**Subject: MHI's Revised Response to US-APWR DCD RAI No.399-2992 Revision 0
(SRP 16 TS Section 3.4)**

MHI's Revised Response to US-APWR DCD RAI No.399-2992
Revision 0

**US-APWR Design Certification
Mitsubishi Heavy Industries
Docket No. 52-021**

QUESTION NO.: 16-298

Figure 16-298.1 Pressurizer Water Volume - Loss of Non-Emergency AC Power to the Station Auxiliaries

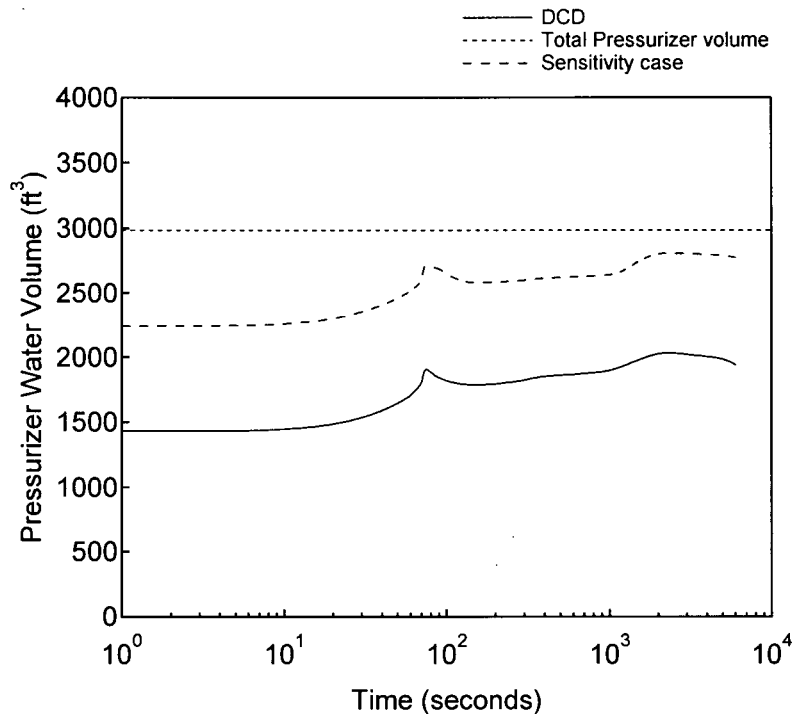
Provide justification for the selected pressurizer water level limit of 92% specified in LCO 3.4.9.a and SR 3.4.9.1. Revise LCO 3.4.9.a, SR 3.4.9.1 and the associated TS bases, as appropriate.

In the APWR DCD Section 15.2, the initial conditions of the pressurizer water volume assumed in all heatup transients are below 1500 cu-ft. (see Figures 15.2.1-4, 15.2.7.4 and 15.2.8-3) which is less than 50% of the total pressurizer water volume (3000 cu-ft). A heatup transient or accident initiated at 92% pressurizer water level constitutes an unanalyzed event which could lead to a water solid pressurizer and liquid release through the pressurizer safety valves.

To confirm the validity of this estimation, MHI performed a sensitivity analysis of the loss of non-emergency AC power to the station auxiliaries assuming that the initial pressurizer water level is 75% span plus uncertainty. Figure 16-298.1 compares the transient of pressurizer water volume for the DCD case and the sensitivity case which is initiated from 75% span plus uncertainty.

For the sensitivity case, the increase in pressurizer water volume is 565 ft³, and the maximum water volume reaches 93.9 %, which is lower than the estimate provided above (95.1%). The reason why the increase in pressurizer water volume is smaller for the sensitivity case is as follows:

When the reactor trip occurs, pressure and water level decrease due to the decrease in the reactor power, which causes condensation in the saturated steam phase and flashing in the saturated water phase of the pressurizer. Since the sensitivity case has a smaller steam volume and larger water volume due to the higher initial pressurizer water level, the condensation volume in the steam phase is smaller while the flashing volume in the water phase is larger than the DCD case. After reactor trip, the pressurizer water level rises again due to decay heat generation. Since the expanded steam volume is larger due to the previously described reason, the calculated pressurizer water volume increase is lower for the sensitivity case.

Although this effect is small, the result of the sensitivity analysis shows that it is conservative to use the net increase in pressurizer water volume in the DCD case to estimate the maximum water volume when starting from the LCO water level plus uncertainty.
